AIRWORTHINESS ADVISORY NOTICE

GFA/AN 29 GENERAL 4

Glider Types Affected:

All gliders with quick connect ball joint control connections including

CORRECT ASSEMBLY  
SIDE CONNECTION

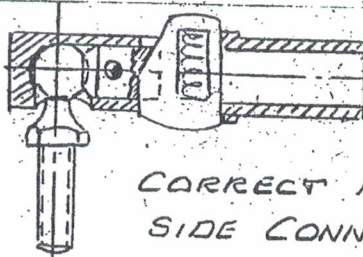
The attached illustrations show the difference between correct and incorrect assembly of the ball joint coupling.

After engaging the coupling apply a pressure of about 5 kilograms (10 - 11 pounds) in the opposite direction to that necessary to engage; that is in the direction to effect disconnection, also check by feel the position of the spring loaded locking wedge to ensure that it is in the fully engaged position.
